THINC  
park city

# Treasure Hill Excavation

**TOWN LIFT MIDSTATION & CREOLE HEIGHT ZONES**  
SWEENEY PROPERTIES MASTER PLAN

**TOWN LIFT MIDSTATION SAMPLE ELEVATIONS**  
 SWEENEY PROPERTIES MASTER PLAN  
 MPE INC.  
 P.O. BOX 2429  
 PARK CITY, UT 84090  
 (801) 840-7077

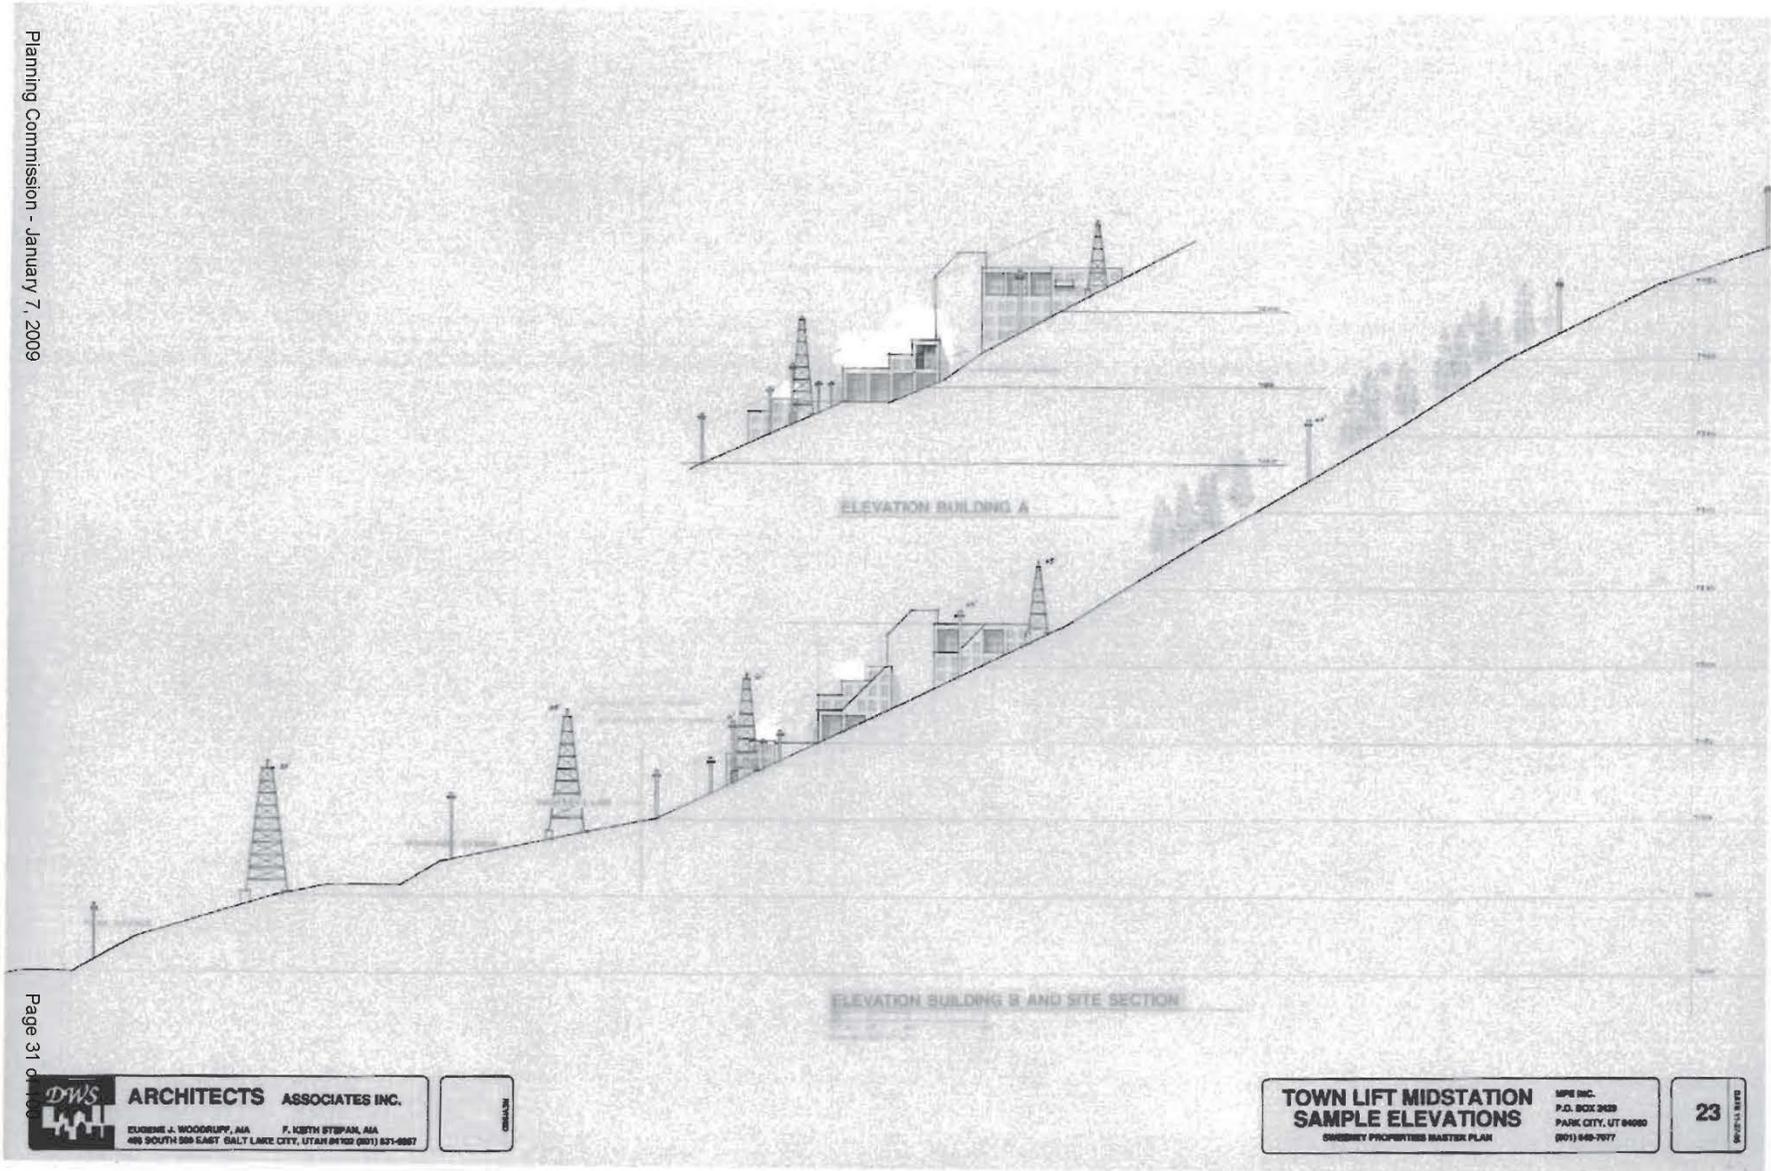
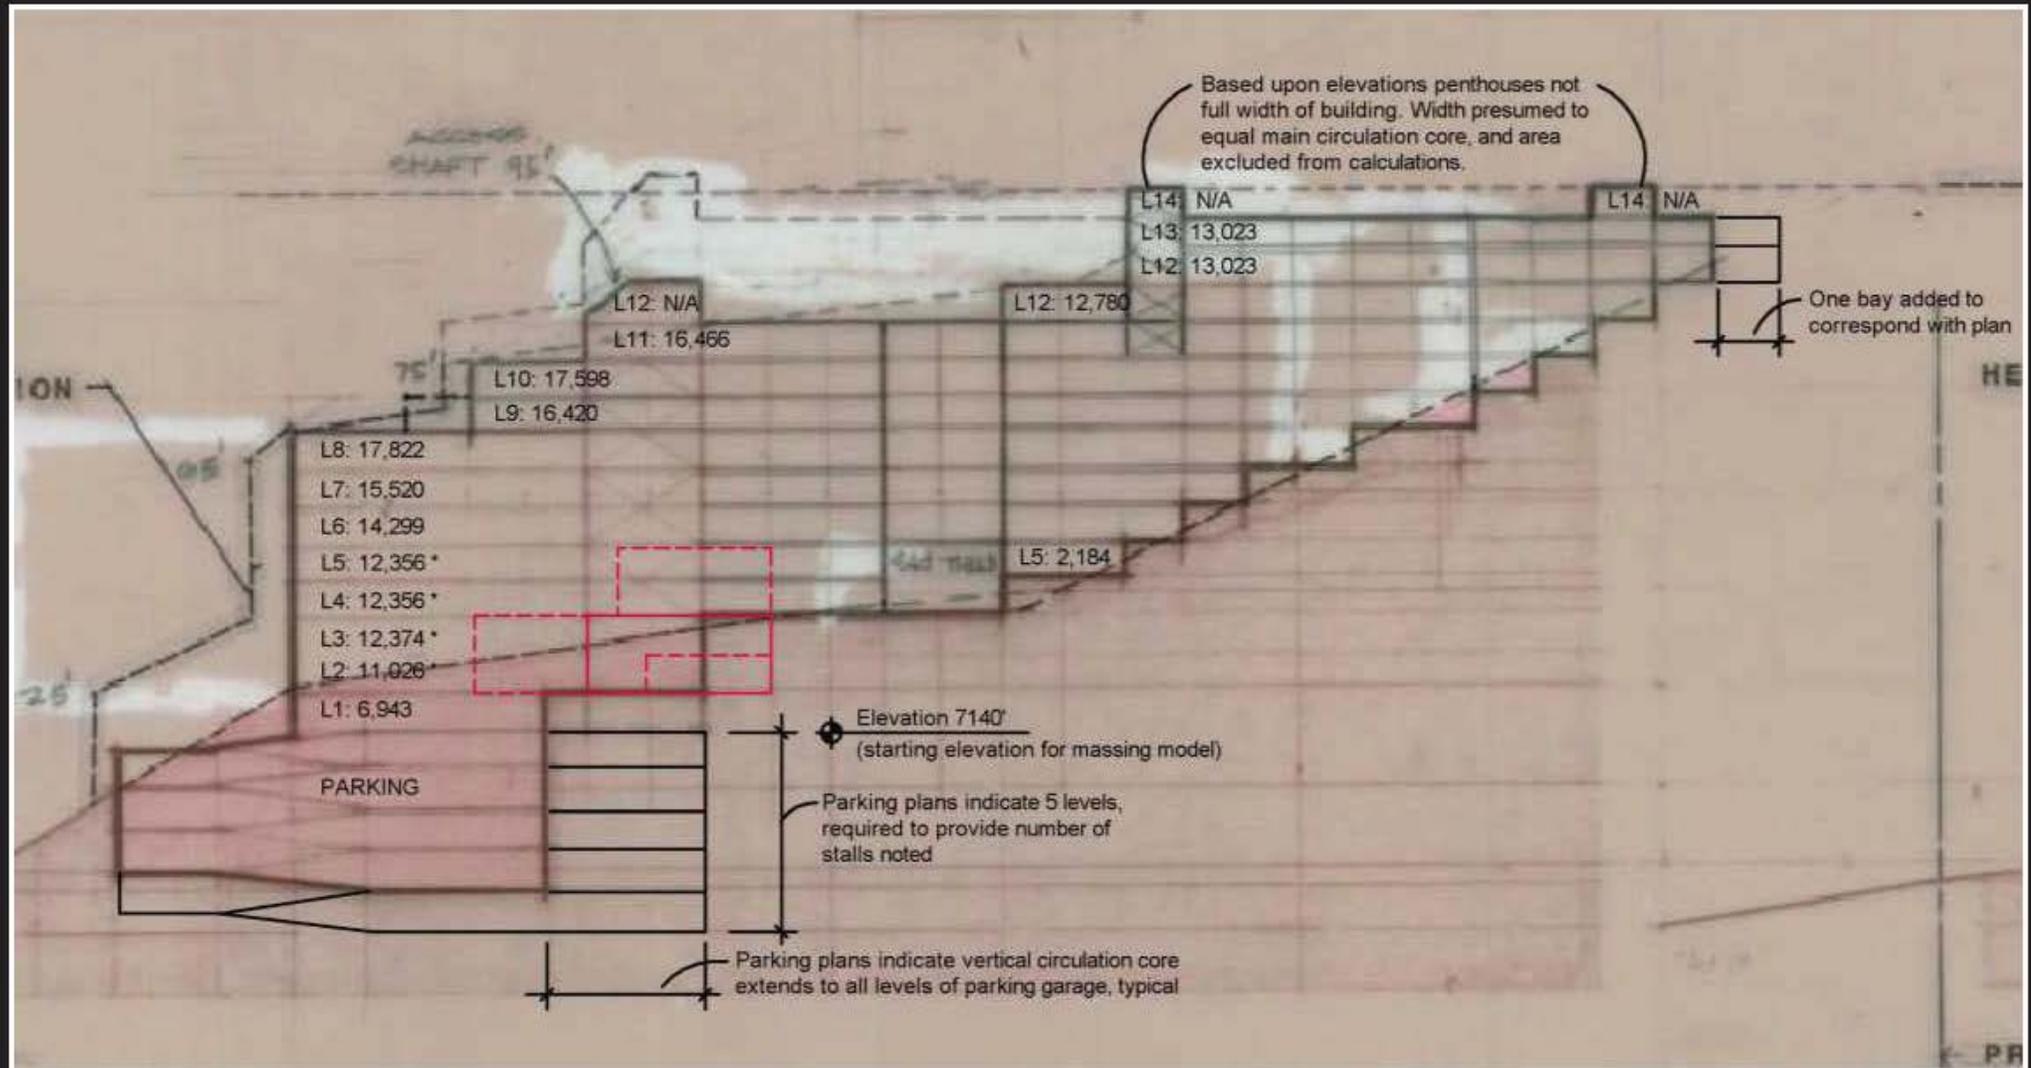
The drawing used by the applicant should be inadmissible. It was a blown up version of the actual drawings.

There was never any intent to use these drawings back in 1985 and 1986 to determine actual square footage.
